<b>Document Description:</b> CP150 WIRELESS_DICOM OPTIONS RELEASE	<b>Document Number:</b> 20014365 <b>Version:</b> A

## Technical Service Bulletin

**Product:** CP150 Electrocardiograph **Date:** 2017-01-15

**Subject:** Release of Wireless (WiFi) and DICOM options for the CP150 ECG

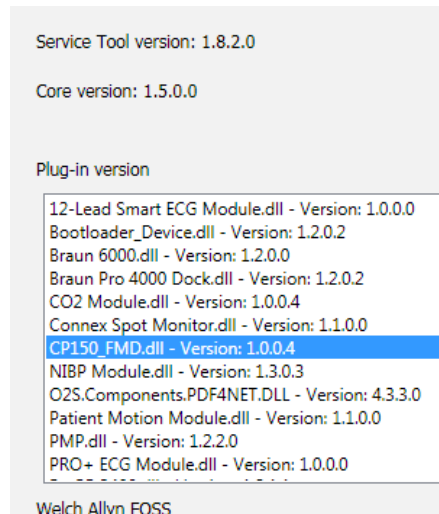
- The optional WiFi capability allows for enhanced workflow alternatives. To identify WiFi enabled devices at a glance, WiFi enabled devices will have the following information (shown in the boxes on the label shown) detailed on the product label:

Configuration (1):

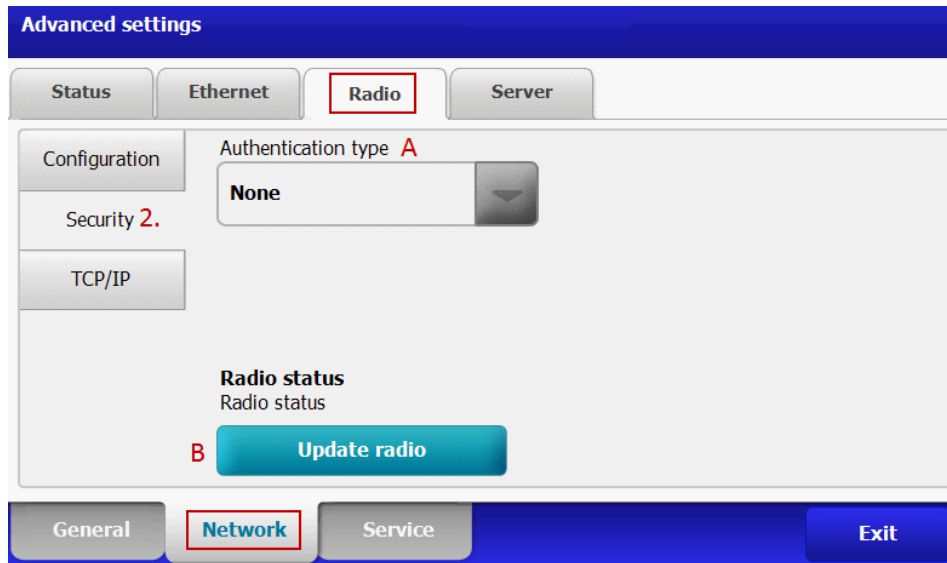
- A. **Enable Radio:** Enable the radio for device communication. When disabled, the radio is not available.
- B. **ESSID:** Identification name of an 802.11 wireless network. Enter the service set identifier (SSID – the name of the access point), maximum of 32 characters.
- C. **Radio Band:** Select the radio band: **a/b/g/n**, **a/b/g**, **a/n**, or **a**.
- D. **Update radio:** Activates all new radio settings not previously selected.  
Note: None of the changed radio settings take effect until the Update radio button is touched.

- **Settings / Advanced** (code: 6345) / **Network / Server / DICOM**  
Server / **DICOM** - page 1 of 3:

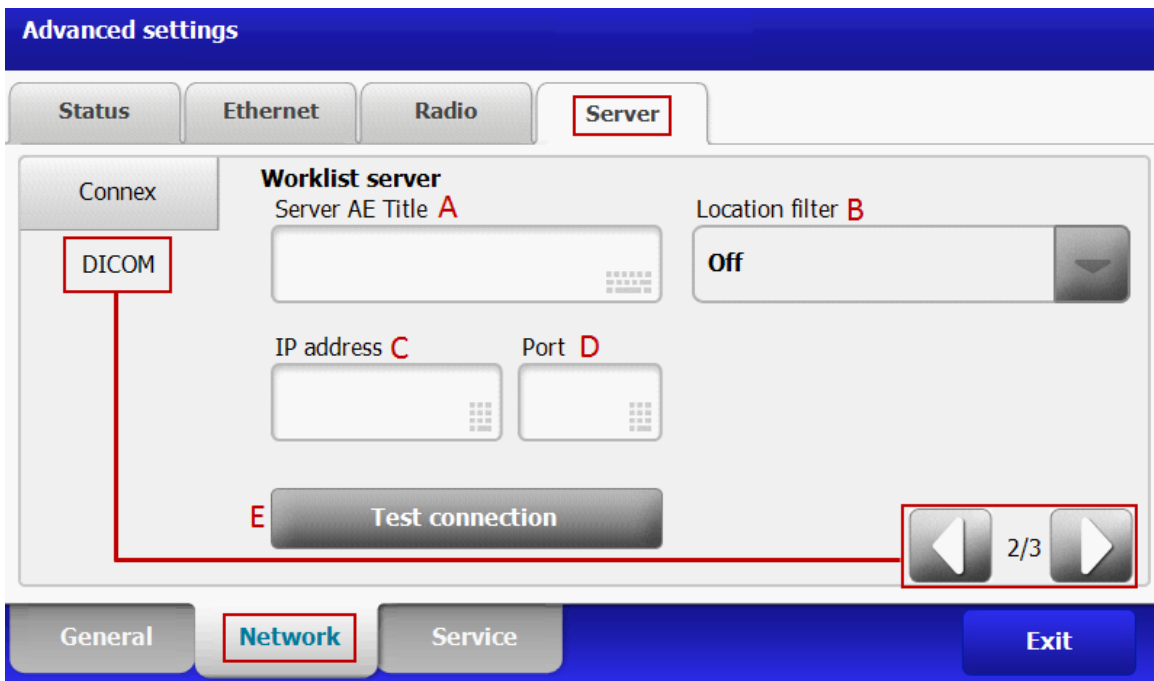
- A. **Enable worklist downloads and ECG DICOM uploads:** Enables DICOM functionality.
- B. **Local AE Title:** Enter the AE Title for the device. Maximum of 16 characters.

Server / **DICOM Worklist Server** info - page 2 of 3:

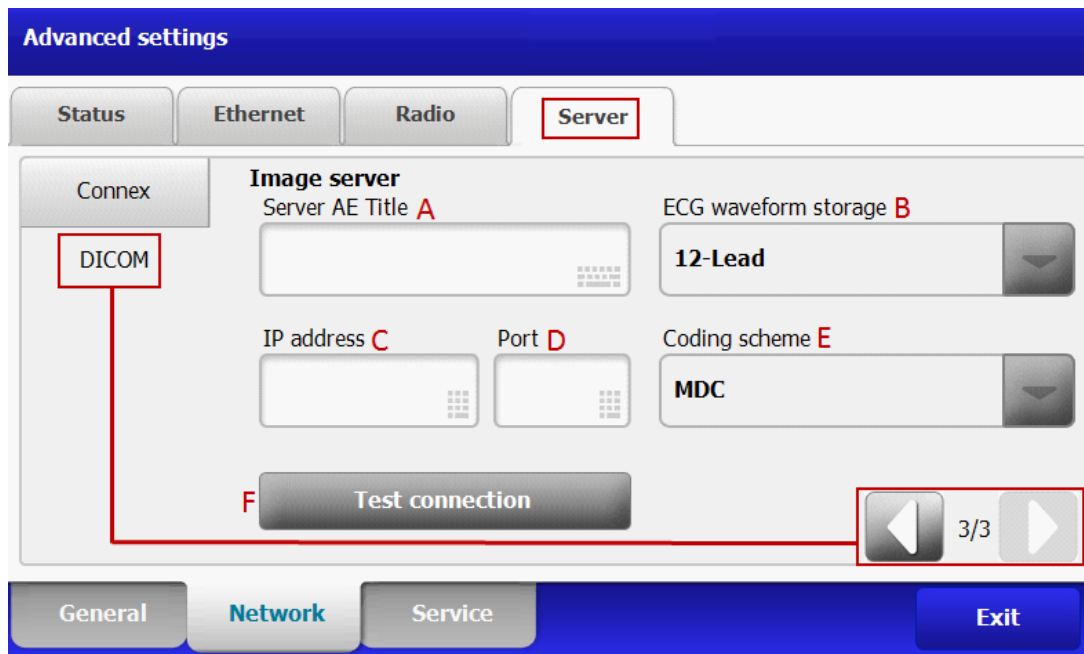
- A. **Server AE Title:** Enter the AE Title for the server. Maximum of 16 characters.
- B. **Location Filter:** Use the drop-down menu to specify the worklist location filtering behavior:
  - a. Off No location filtering
  - b. Local AE Title Retrieve orders scheduled for this device's AE Title
  - c. Device ID / Practice ID Retrieve orders where Institution Name = Practice ID and Current Patient Location = Device ID.
- C. **IP address:** Enter the Worklist Server's IP address.
- D. **Port:** Enter the Worklist Server's Port number. (The port number is set by the network administrator.)
- E. **Test connection:** Touching this button will test the connection with the Worklist Server.
